**CITY OF PORTLAND, MAINE
DEVELOPMENT REVIEW APPLICATION
PLANNING DEPARTMENT PROCESSING FORM
Planning Copy**

Amendment to Plan - University Park

At the request of Jay Reynolds, Development Review Coordinator, Land Use Consultants is submitting an application amendment and request for minor changes to the approved Grading Plan for Yale Court (Sheet C-9), on behalf of the Applicant, Yale Court Limited Partners. This request is a result of minor grading changes around the buildings required to clarify grading directly around each unit and coordinate the typical grading indicated on structural foundation details with the approved Grading Plan. Initially, construction sketches were issued to the contractor as a field directive for revisions at each unit. However, Mr. Reynolds has indicated that these revisions must be reviewed by the City as an amendment to the approved Site Plan. No changes were made which would alter or revise drainage, drainage patterns, drainage calculations, stormwater management, water quality treatment, impervious areas or other permit compliance issues. It is our understanding these changes may be considered diminutive in scope and can be reviewed at the admin

TITLE:
REVISED PARKING LAYOUT

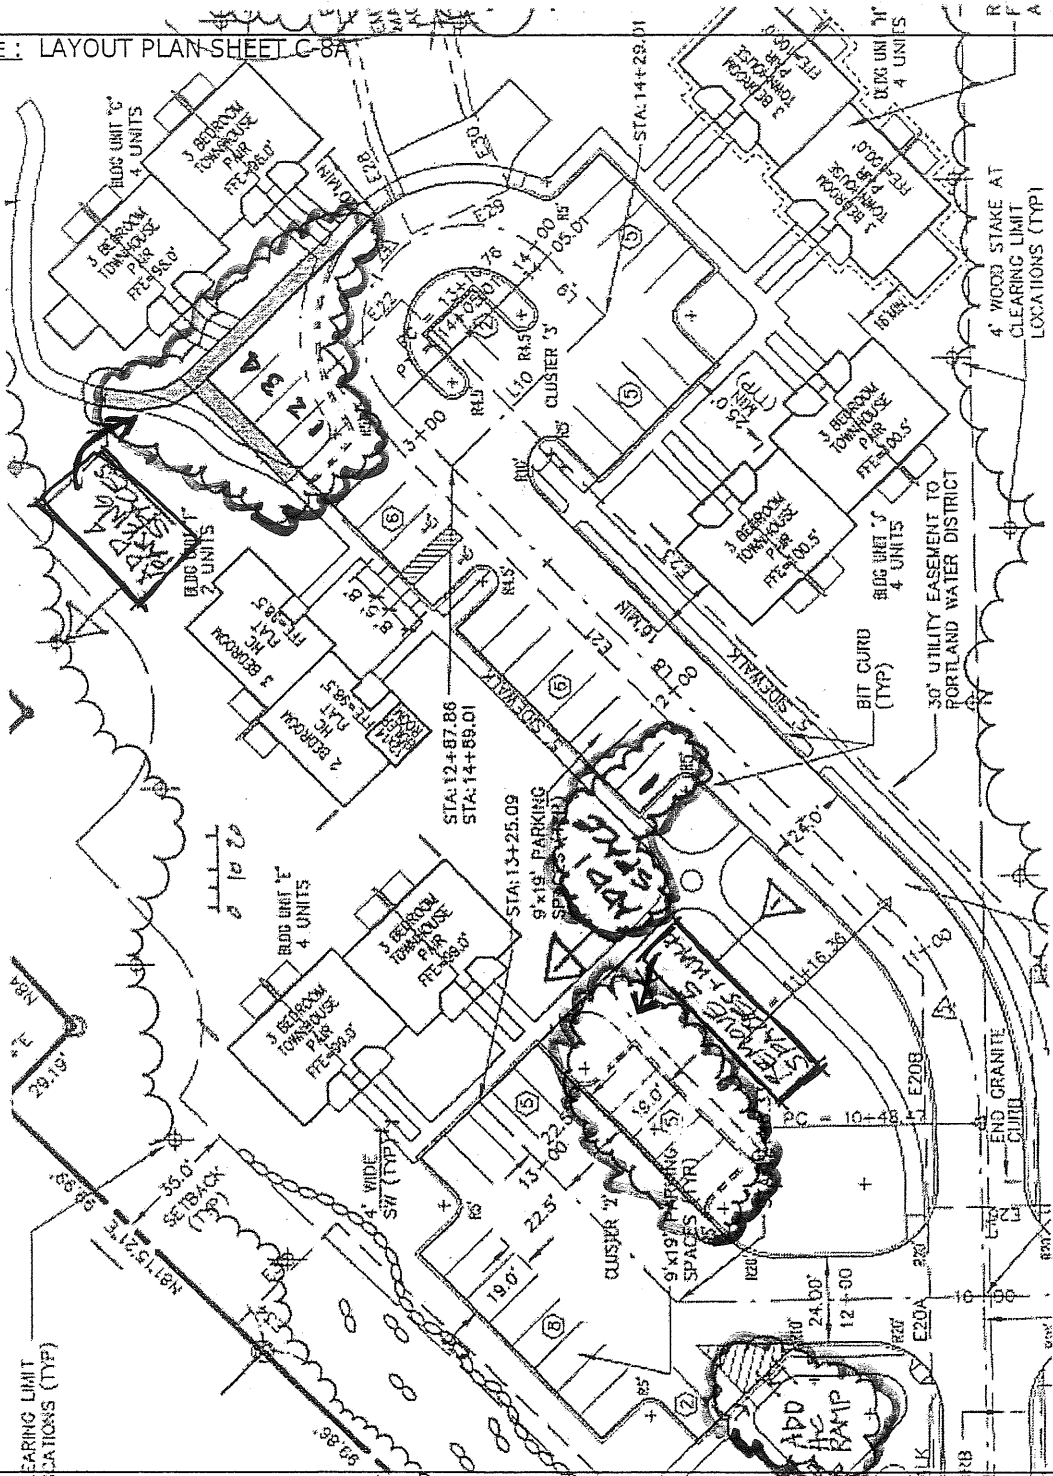
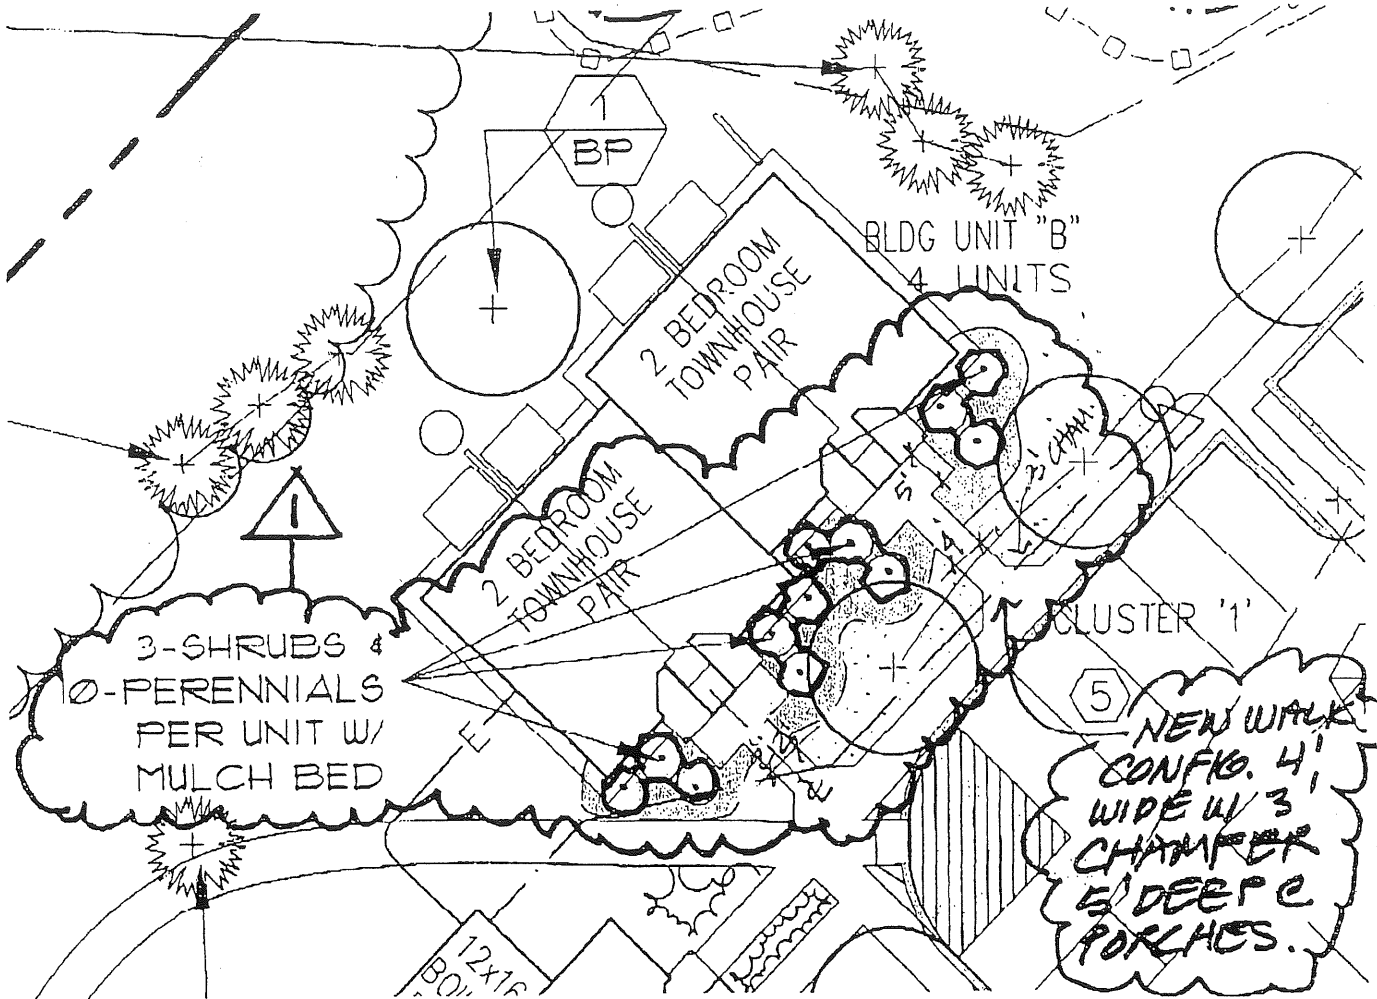
1. Remove and relocate five parking stalls as illustrated on attached *Sketch LSK-1-Revised Parking Layout*. This change was discussed with the City planning staff prior to bid and was issued to bidders in the sketch plan format.

Drawing Title:
**COMMON
WALL HAUNCH**
Scale: 1" = 1'-0"
Date: 02/14/03
Revised:

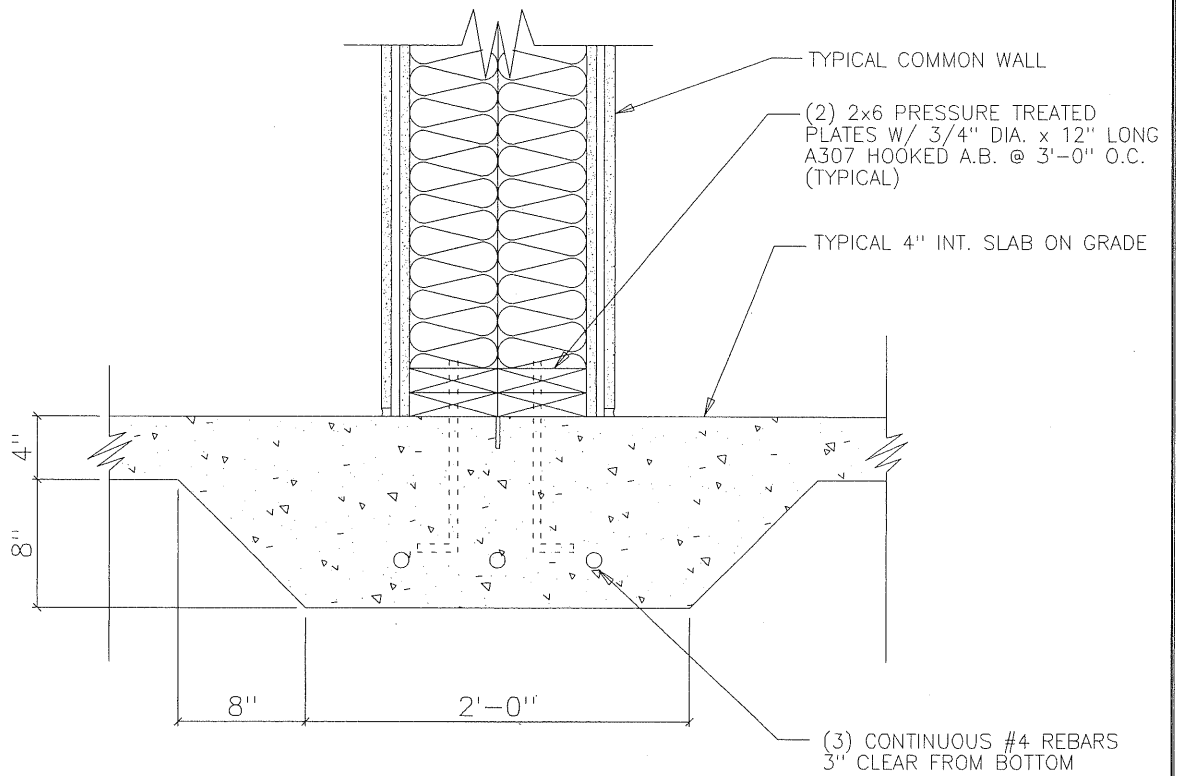
PROVIDE AT ALL COMMON WALL LOCATIONS
IN LIEU OF DETAIL SHOWN AT D / A6.1

23. Replace Detail C/A6.1 with SKA-1 (attached).
24. On the foundation drawings (see plans and Detail C&D/A6.1) a short foundation wall is indicated between unit pairs at both level and stepped conditions. This detail was designed to allow the framing of the building without requiring slab placement, as it was anticipated that foundation work would take place in winter. Whereas this may not be the case, alternative “slab bearing” details (SK2, Sheets 1, 2 and 3 of 3) have been provided to allow the contractor to take advantage of this system if they feel it is to their cost benefit. Bidding General Contractors may choose between either of these two (concrete foundation wall or slab) approved bearing systems.

Drawing Title:
**COMMON FDN.
BUILDING "C"**
Scale: 1" = 1'-0"
Date: 02/14/03
Revised:

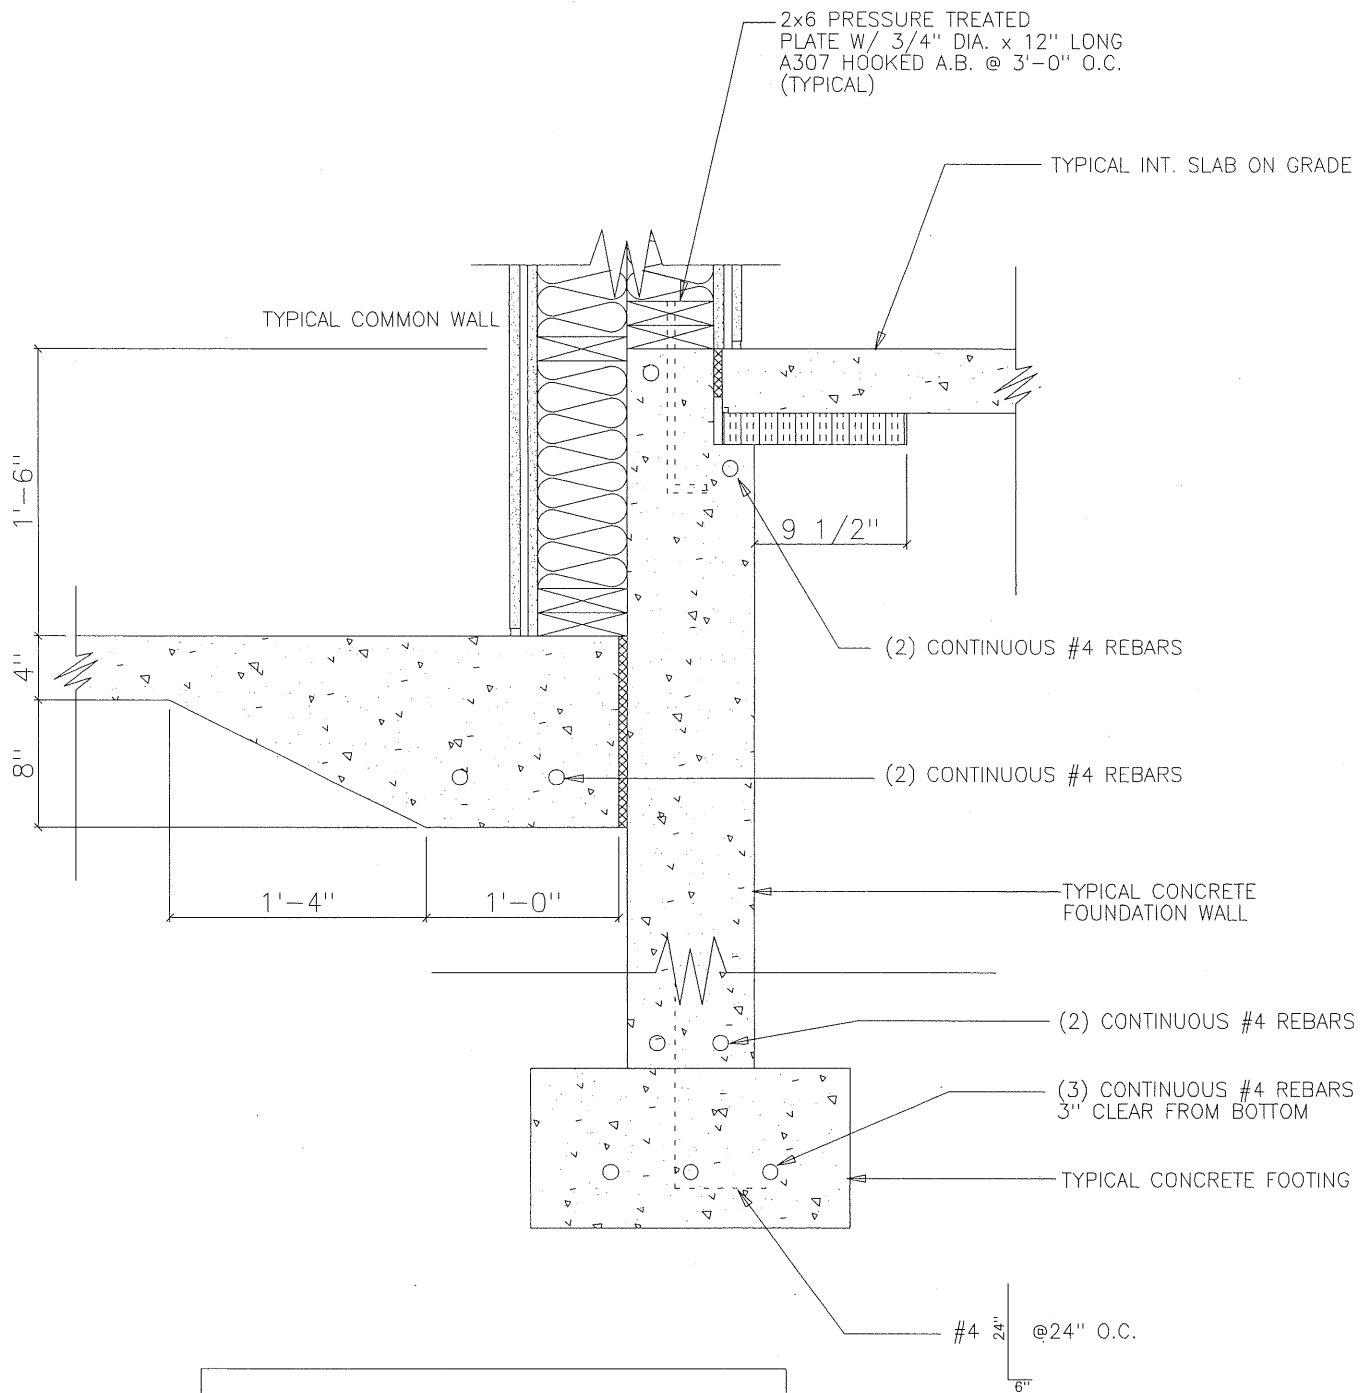
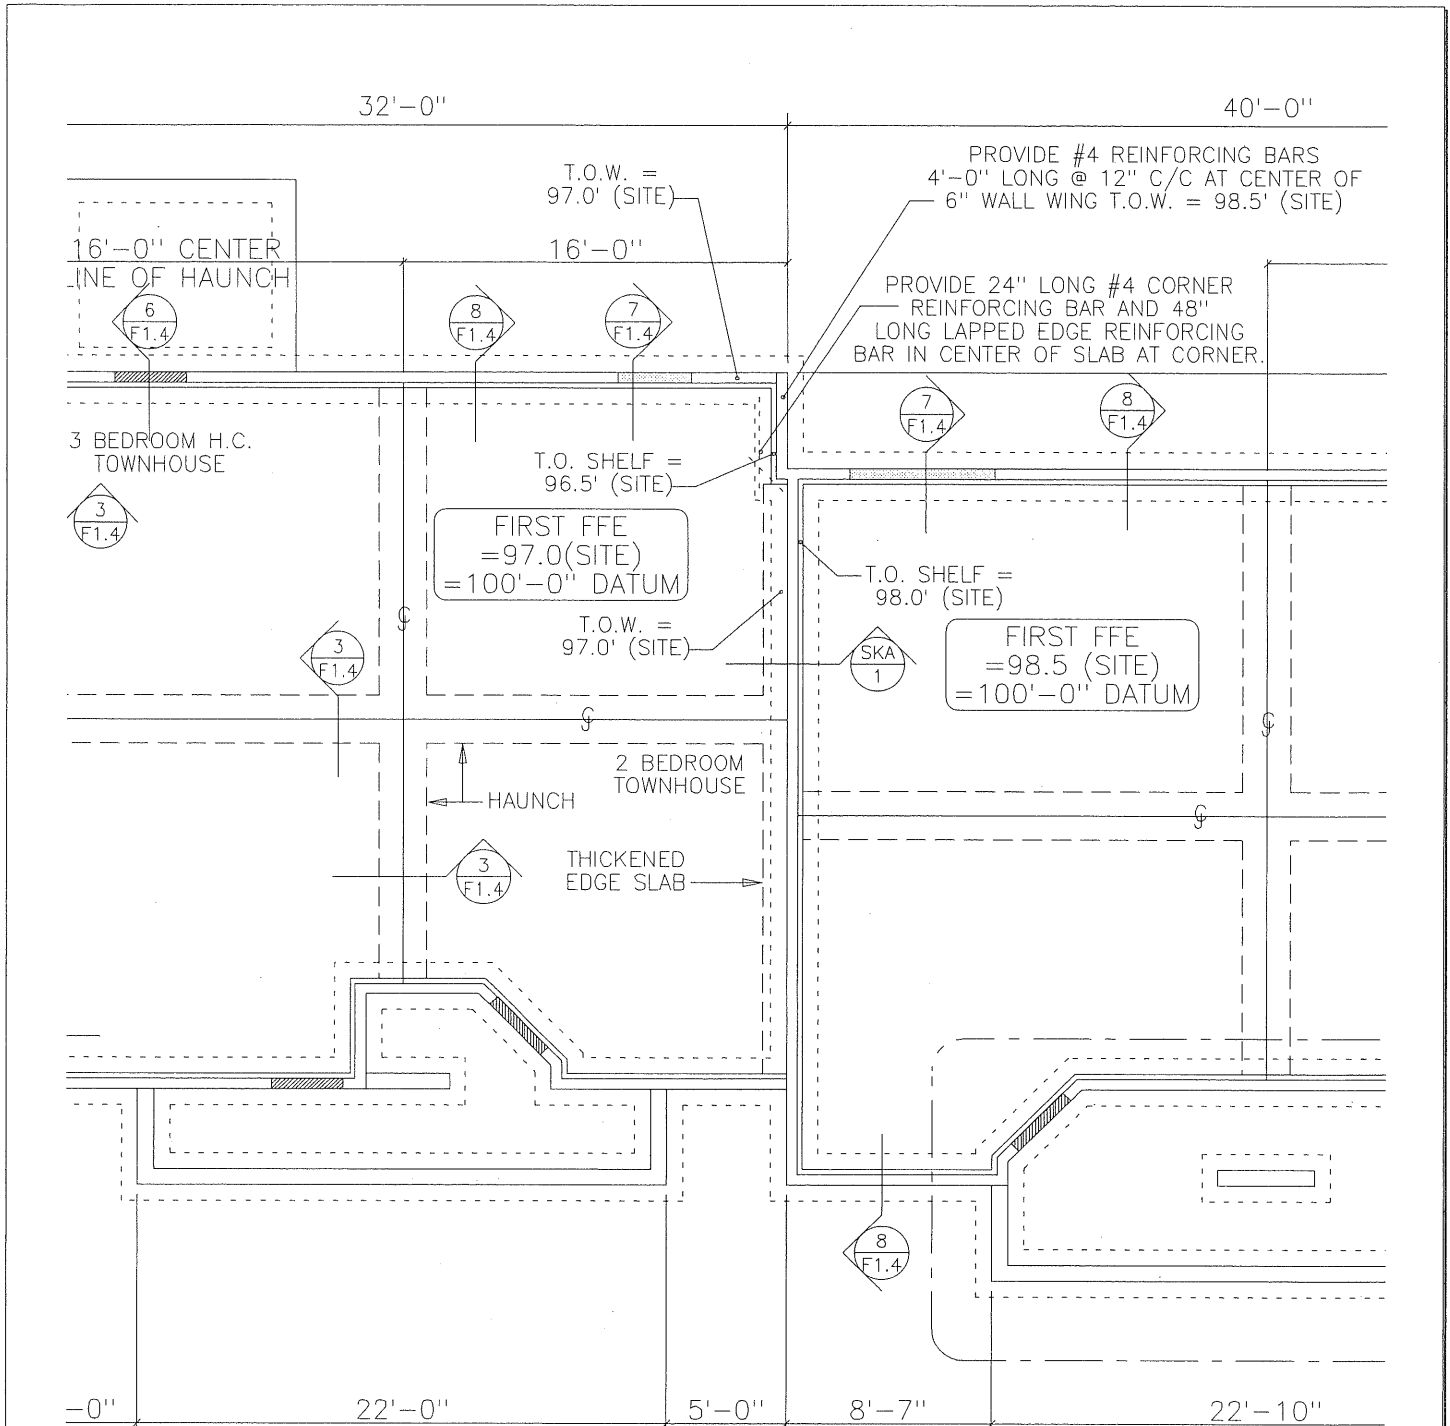
PROVIDE AT COMMON WALL LOCATION AT BUILDING "C"
IN LIEU OF DETAIL SHOWN AT C / A6.1

Drawing Title:
**SILL PAN
 DETAIL**
 Scale: NTS
 Date: 02/14/03
 Revised:

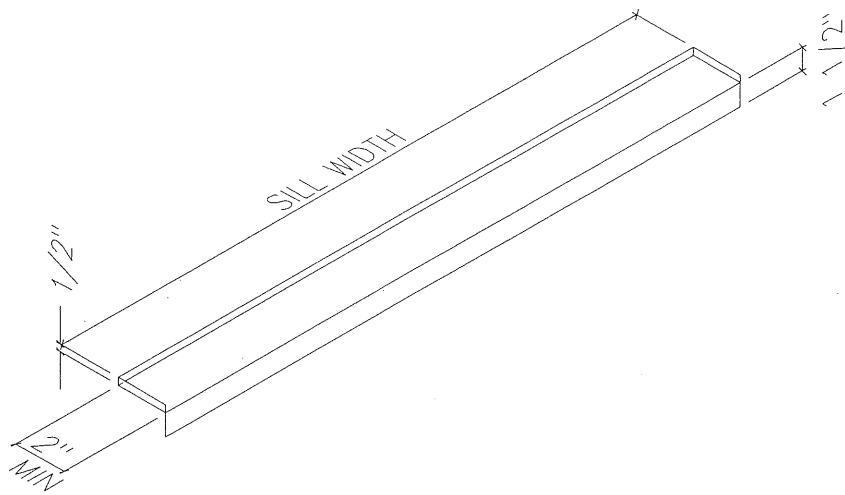
25. As specified on the Door Schedule, provide a soldered copper pan below all exterior doors, set on a bed of asphalt adhesive, in accordance with detail SKA-3, attached.

Addendum 04

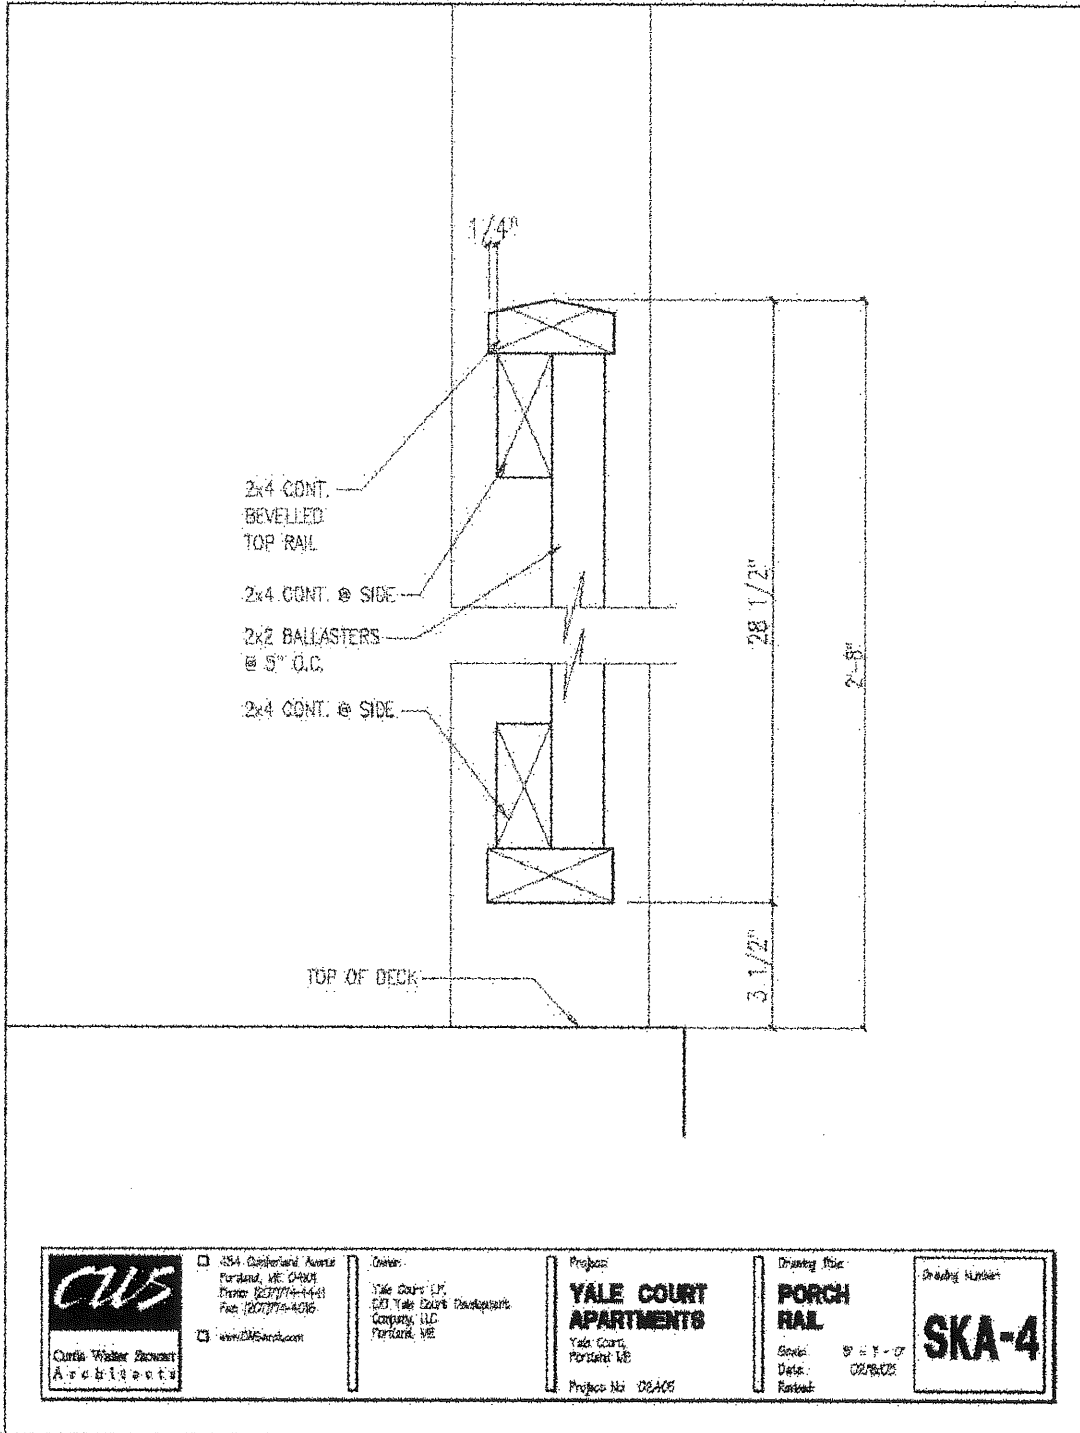
1. On Addendum 03, modify the Subject line to read “Addendum 03”.
2. Site work contractor shall not carry the cost of a permit for installation of the gas line.
3. All site work contractors shall carry the cost of a) installing the 8” water meter and meter pit at the Yale Court PRUD property line and b) Portland Water District inspection fees for installing the (10) services on Yale Street.
4. The owner shall carry the cost of all City of Portland site inspection fees.
5. Modify Item “Q” on the “Exterior Elevations Legend” on Drawing A3.1 to read “Cedar Rail System as per Detail SKA-4, Solid Body Stain: White” (see detail below, N.T.S.)

1. Modify Item 5 in Addendum 04 to read: “Modify Item. “Q” on the “Exterior Elevations Legend” on Drawings A3.1, **A3.2, A3.3, A3.4 and A3.5** to read “Cedar Rail System as per Detail SKA-4, Solid Body Stain: White” (see detail below, N.T.S.)”.
